APPEAL SUMMARY

Appeal ID: 22157

Project Address: 5510 N Denver Ave

RECONSIDERATION OF APPEAL ID:
22001

HIGHLIGHTED DETAILS ON A8.01

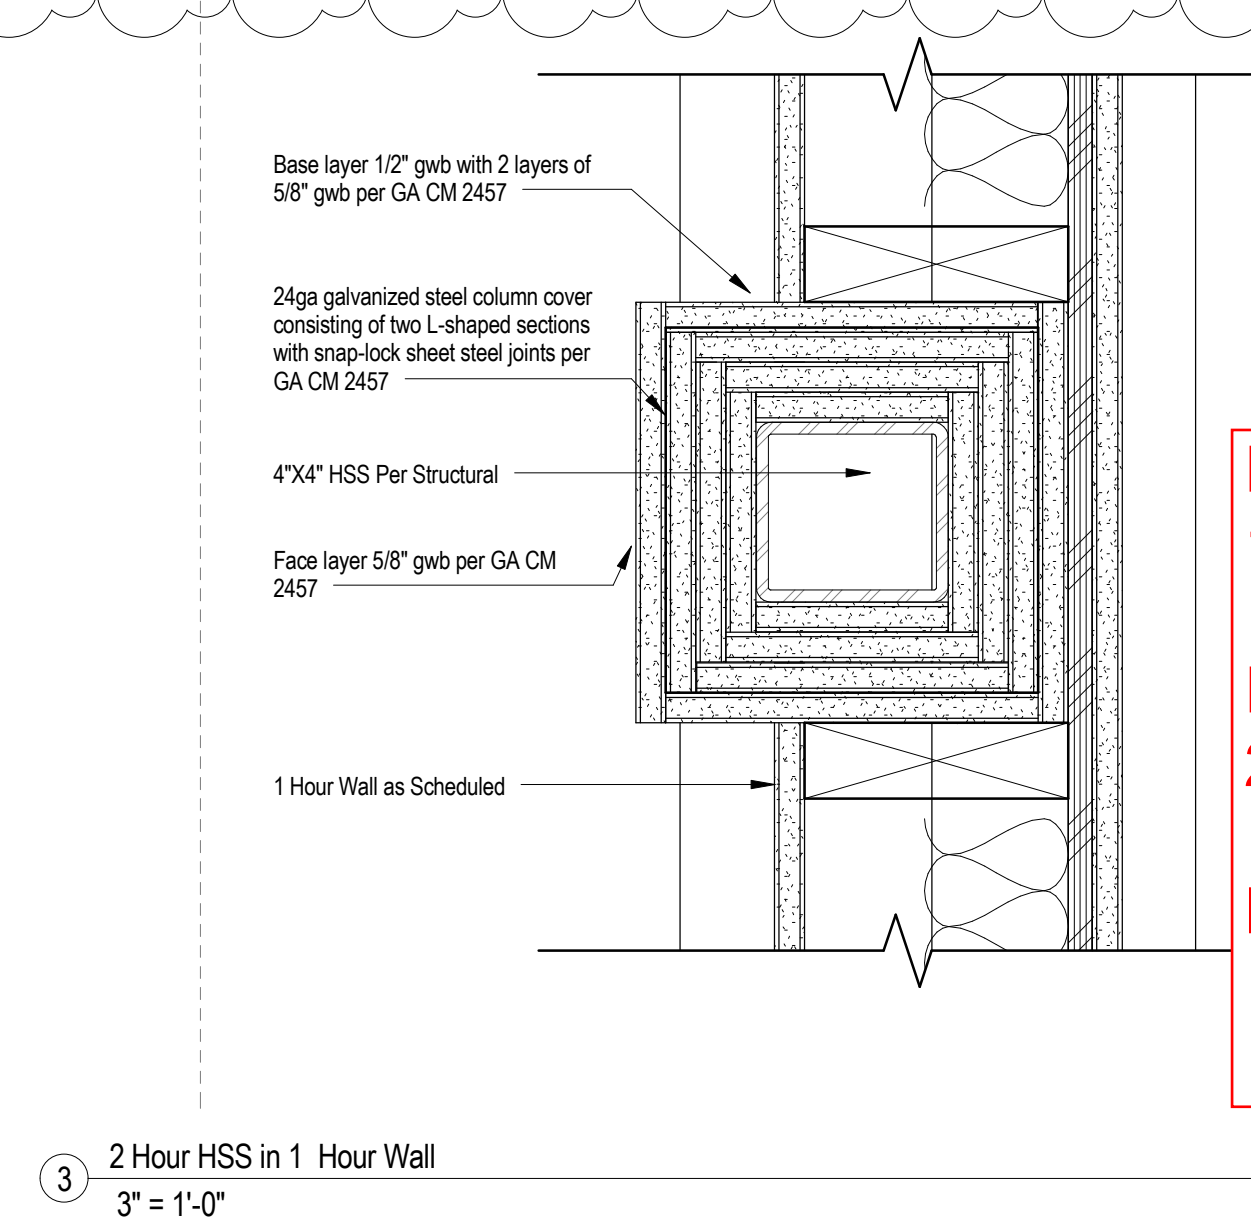
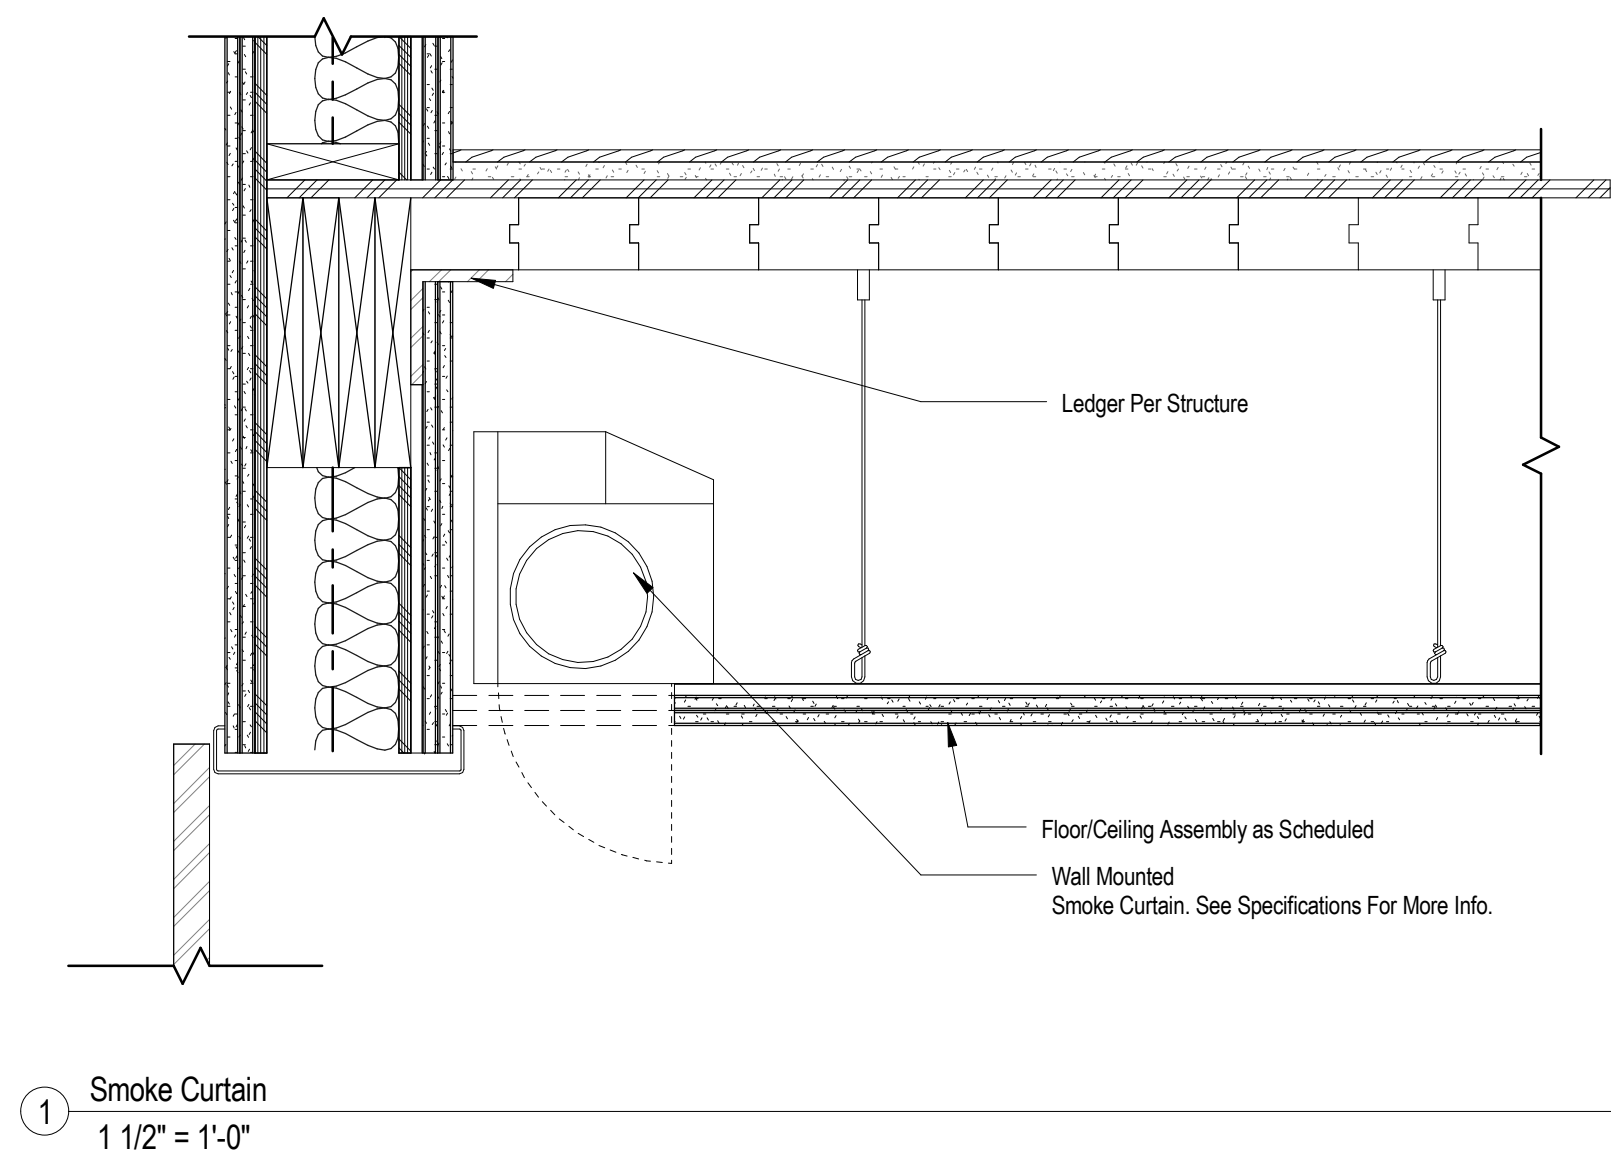
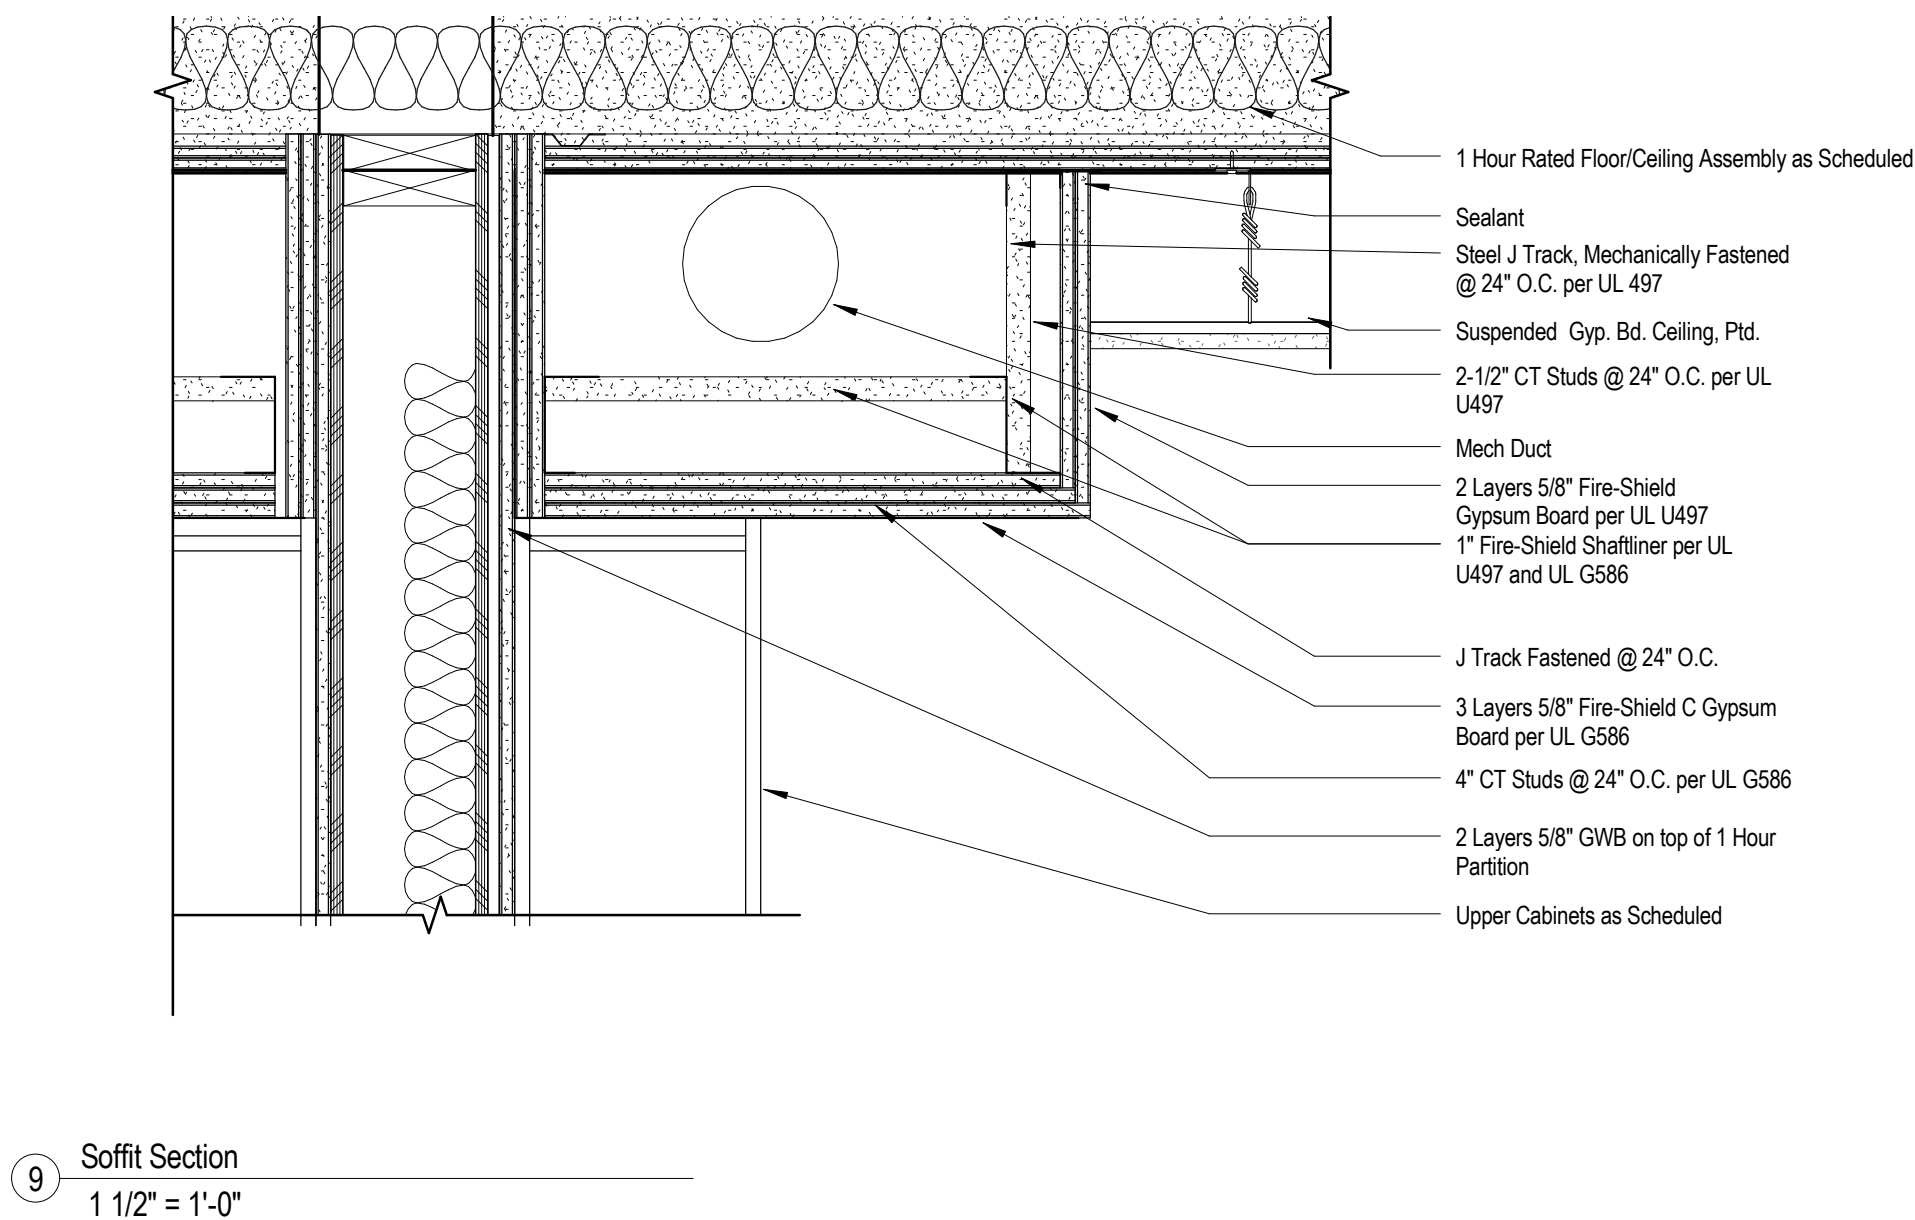
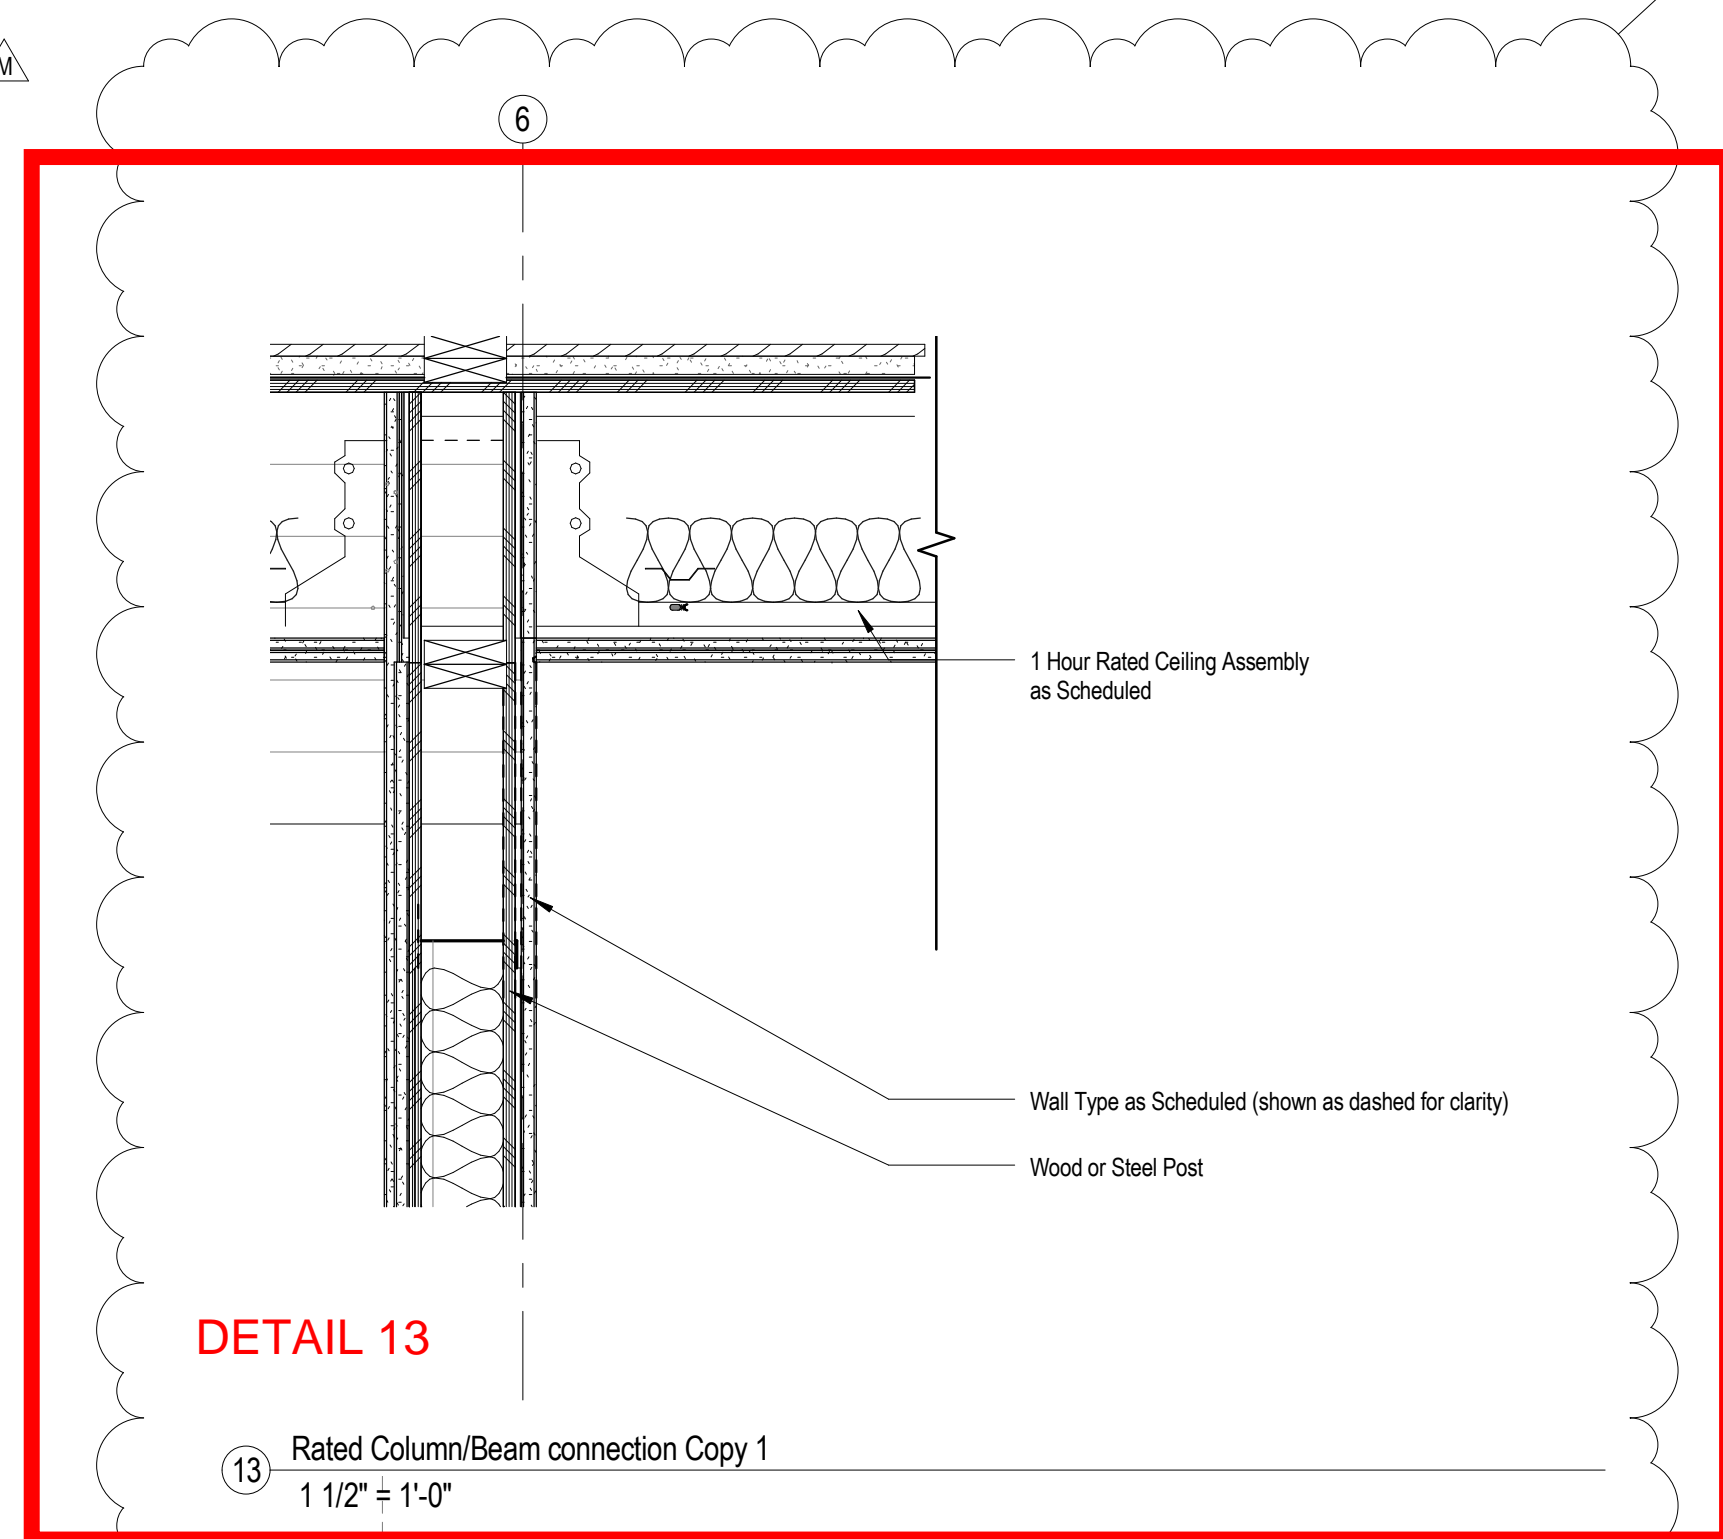
The details shown on a8.01, Exhibit 5, details 12 and 13 show the head details for the condition with and without glulam beam.

We were also asked to demonstrate that the post can be in-line with the wall, which is now the case with the revised details (previously the gypsum wrap was pushing the post out of line with the wall).
